Conformance Review Report

Uploaded Specification · job 93b13bf4 · Powered by VeriSpec Intelligence · generated 2026-08-22 03:35 UTC

Project-level: figures cover the NE Hall Data Center upgrade. IT load summary lists '97.5KW NE HALL 80.2KW WSEC 55KW 20% SPARE 100KW WSEC NON-UPS 278KW TOTAL TOTAL 330KW'; utility capacity from existing MSB bus rating, not a stated service entrance size.

AutoCAD 2020 UNL Nebraska Hall Data Center Upgrade E5.1 NE Hall DC Expansion MEI E5.1

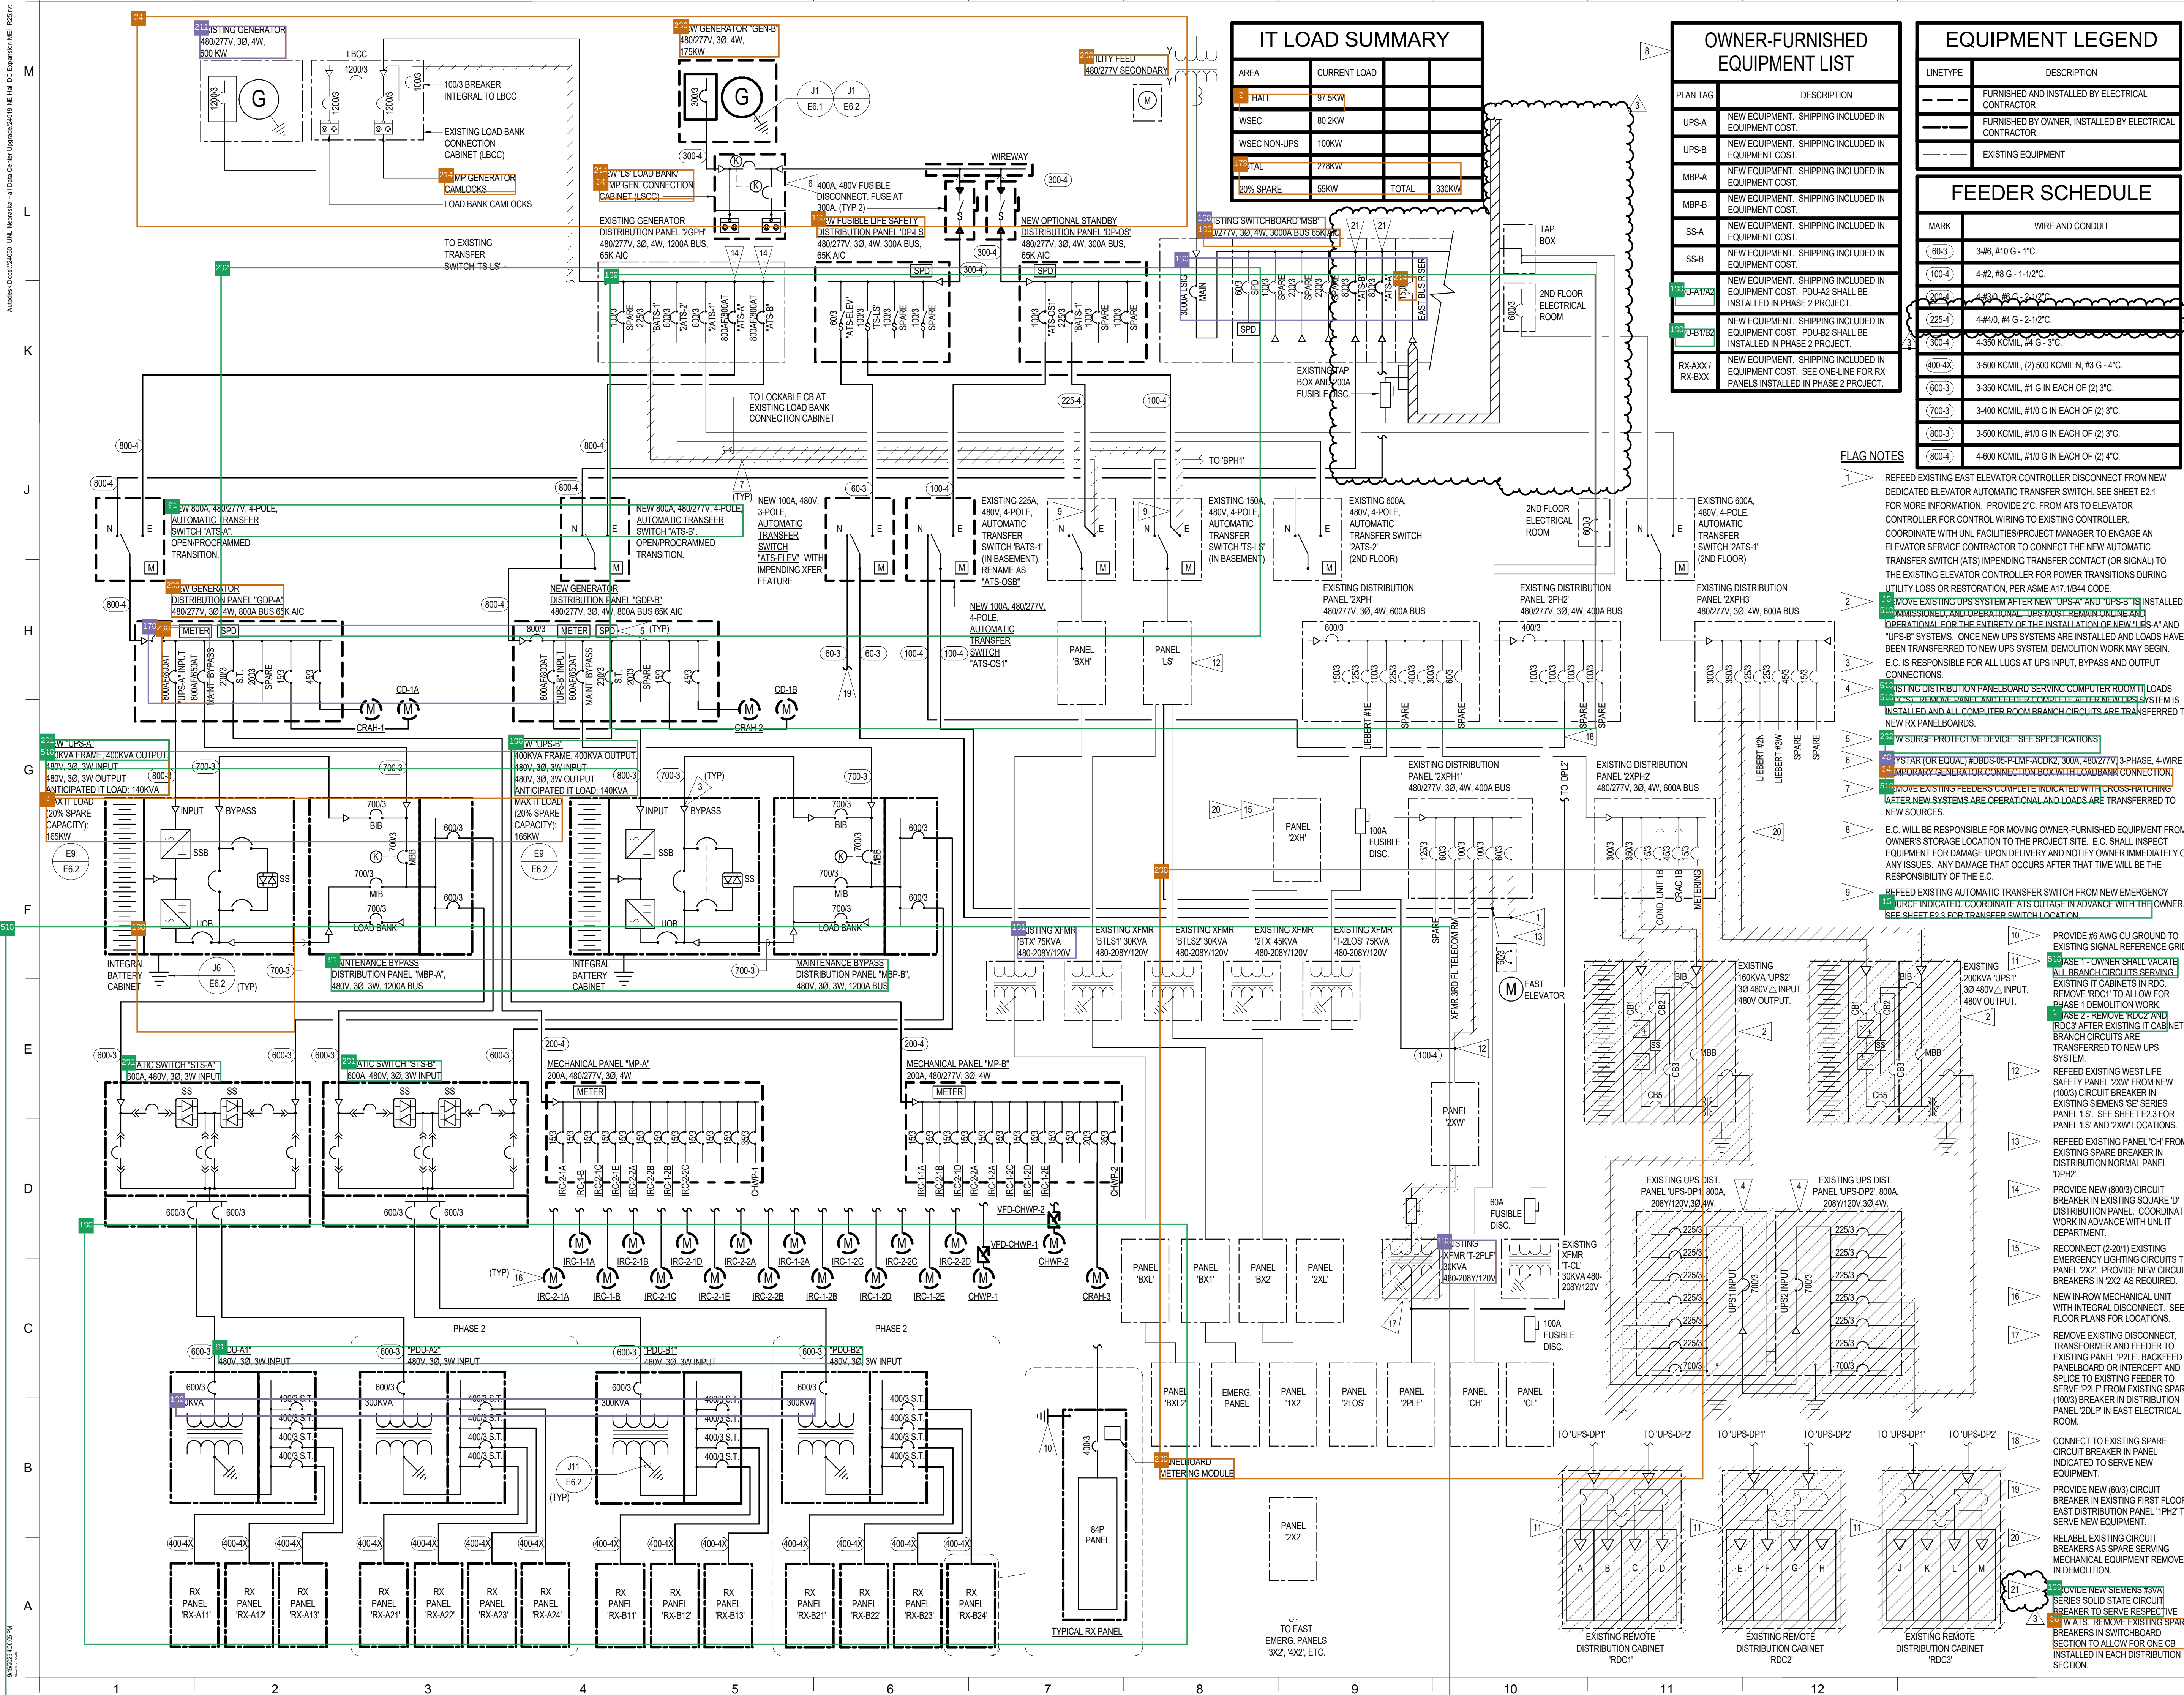
Derived analysis: Tracing the one-line on sheet E5.1, the building is served by a single utility service — one 'UTILITY FEED 480/277V SECONDARY' terminating in the single existing switchboard 'MSB'. No second utility service, second transformer, or alternate service entrance is shown anywhere in the package; all downstream redundancy (UPS-A/B, generators) sits behind this one service entrance. Loss of the single utility feed forces all critical load onto generator/UPS ride-through, so the utility entrance itself is a single point of failure.

The one-line shows two generators of unequal capacity: an existing 600KW generator and a new 175KW natural gas generator ('GEN-B'). The sheet's own IT LOAD SUMMARY lists current IT load at 278KW total (330KW total with 20% spare). The new 175KW generator cannot individually support the entire IT load under any reading of those figures, directly contradicting the requirement that each generator be

⚠ **Generator capacity vs IT load:** one-line (E5.1) shows 'NEW GENERATOR "GEN-B" ... 175KW' and 'EXISTING GENERATOR ... 600 KW' while the same sheet's IT LOAD SUMMARY totals 278KW current / 330KW with 20% spare; the 175KW unit is undersized to carry the entire IT load alone. Also note an internal tension

△ E5.1 (page 42) one-line tags an in-row unit 'IRC-1-B' (listed twice among the MP-A/MP-B branch breakers), while M4.1 (page 25) riser tags the Phase-1 size-1 unit 'IRC-1-1B'; 'IRC-1-B' matches no tag on the mechanical riser and appears to be a typo for IRC-1-1B within the drawing set. Recommend recon

Recommendation: Evaluate a second utility service entrance (or alternate feeder from a separate utility source/transformer) with automatic transfer ahead of the switchboard, or confirm with the utility that the single campus feed meets the facility's availability target.
